PLANNING, ZONING, & BUILDING DEPARTMENT
PZ&B Staff Memorandum: Town Council Development Review

SUBJECT: ZON-23-019 (COA-23-002) 363 COCOANUT ROW THE VINETA HOTEL (COMBO)

MEETING: MARCH 15, 2023

EXISTING POOL BANQUET ROOM ELEVATION

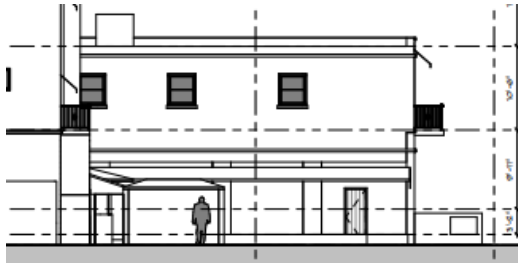
Within the rear pool deck area, the applicant is proposing a new operable NANA wall storefront system. This new fenestration alteration will allow the interior pool lounge to ‘open up’ onto the open-air pool deck area and provide for access to outdoor dining and drinking. A total of 52 seats are proposed in and around the pool bar towards the eastern portion of the site—16 of which are

PROPOSED POOL LOUNGE ROOM ELEVATION

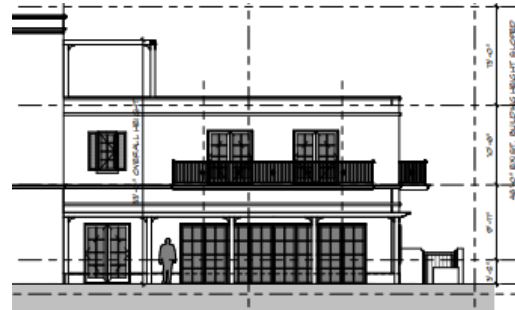
For all of the outdoor café seating—a total of 60 outdoor seats—the Town Council will review and approved them in accordance with the Special Exception criteria. And as previously mentioned, there was historical evidence of outdoor dining service in both of these areas.

- First, the nightclub use should be expressly confined to the interior space of the main dining room only; and
- Second, the front courtyard outdoor café seating should be limited to service hours till 10pm; and
- Third, the Outdoor Café pool lounge seating should be limited to service hours till 9pm; and
- Fourth, no outdoor music.

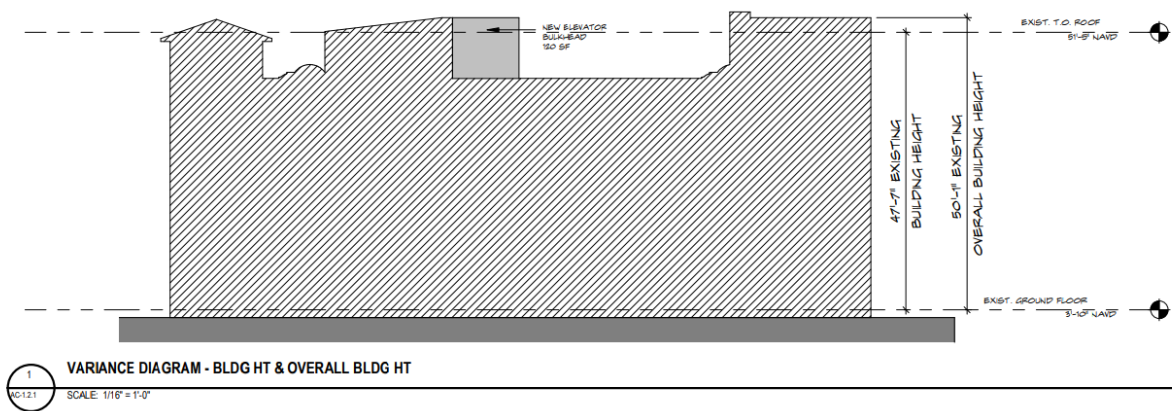
VARIANCE 2: Sec. 134-948(8)d: A variance to exceed the maximum allowable height for new rooftop construction specifically to replace an elevator and stair bulkhead on the rooftop of a nonconforming four-story building with a height of 47.6 ft in lieu of the 23.5 ft maximum building height allowed.

VARIANCE 3: Sec. 134-948(8)d: A variance to exceed the maximum allowable height for new rooftop construction specifically a rooftop trellis on a nonconforming third floor and of a nonconforming four-story building with a height of 33'0" in lieu of 23'6" maximum height and 26'6" maximum building height permitted.

As it pertains to Variance #2 and #3 to exceed maximum height of rooftop trellis on a nonconforming third floor and to replace an elevator and stair bulkhead on the nonconforming building, staff has no objections to the request as it technical in nature as the Code does not contemplate nonconforming buildings in zoning districts as it pertains to rooftop improvements when the zoning limits the number of stories below that existing edifice.

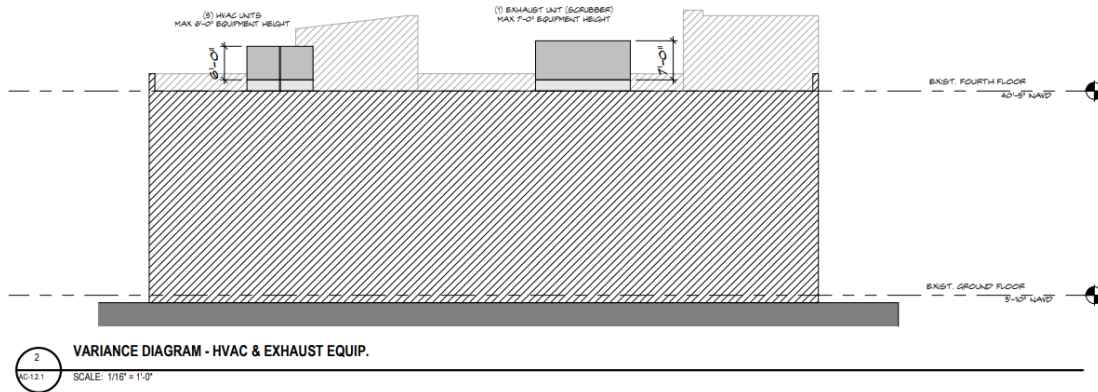
VARIANCE 4: Sec. 134-1607(1): A variance to exceed the maximum allowable height for the installation of rooftop air conditioning units (five) at a height of 108” (9’) above the maximum height permitted in lieu of the 48” (4’) maximum height allowed.

VARIANCE 5: Sec. 134-1607(1): A variance to exceed the maximum allowable height for a roof top commercial kitchen exhaust scrubber at a height of 84” (7’) above the maximum height permitted in lieu of the 36” (3’) maximum height allowed.

As it pertains to Variance #4 and #5 to exceed maximum height of mechanical equipment (AC and Scrubber) on the existing roof. Staff has no objections to the request as it is the logical placement of such equipment, provided that the existing parapet wall or other screening methods adequately mitigate any negative visual impact when viewing the building from within the r-o-w or across the street. The placement of the equipment is setback from the immediate edges of the building and should be visually obscured. Staff would recommend that the applicant install sound attenuating material to ensure that the mechanical noise level does not become disruptive to the residential neighbors abutting the subject property to the south and to the east in the form of a noise barrier that offers soundproofing.
